**Subject:** Docket 71-9036 : Application for Letter of Authorization

ISOFLEX Radioactive LLC (ISO-RAD) is a Louisiana Department for Environmental Quality (LDEQ) licensee. As discussed with Mr. Bernard White, Senior Project Manager, Division of Fuel Management, ISO-RAD is submitting the following application for a Letter of Authorization for a variance to the nameplate for the USA/9036/B(U)-96 Type B(U) package Docket Number 71-9036.

Model C-1 Nameplate  
ISOFLEX Radiatactive LLC

| <b>B</b>  | <b>200306-100</b>           | <b>0</b>      |

Current Nameplate on the drums in ISO-RAD's possession

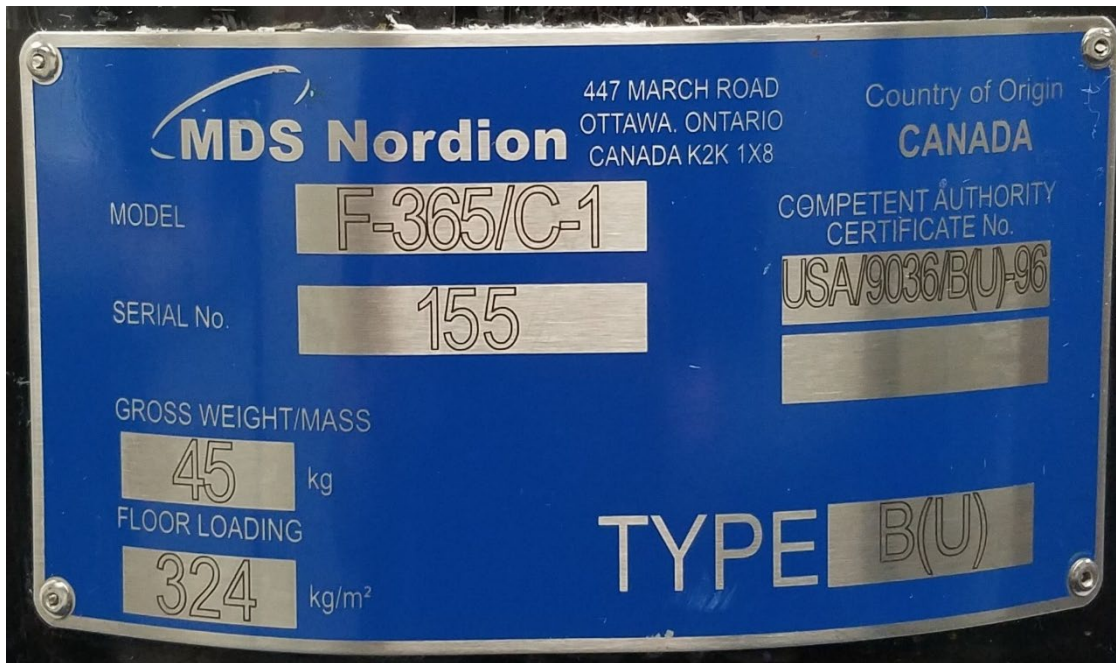
- 1) Allow the transportation of the two 71-9036 containers S/N 146 and S/N 153 with Nordion nameplates (see attached photo) from JFK to ISO-RAD’s facility in St. Rose, LA. The above containers are in a secure dangerous goods cage at JFK airport and the airline would like to have these out of their warehouse as soon as practicable. The transportation of the

- 2) Allow the continued use of the “Nordion” nameplate on the drum for a maximum period of four (4) months (see attached photo) from the issuance of the Letter of Authorization. This will enable ISO-RAD to have the proposed new nameplates manufactured and installed. ISO-RAD will notify the USNRC once this task is completed.
- 3) Allow the use of an ISOFLEX Radioactive LLC nameplate until the current expiration date of the USA/9036/B(U)-96 certificate on October 31, 2021. The proposed ISOFLEX Radioactive LLC nameplate drawing is attached.
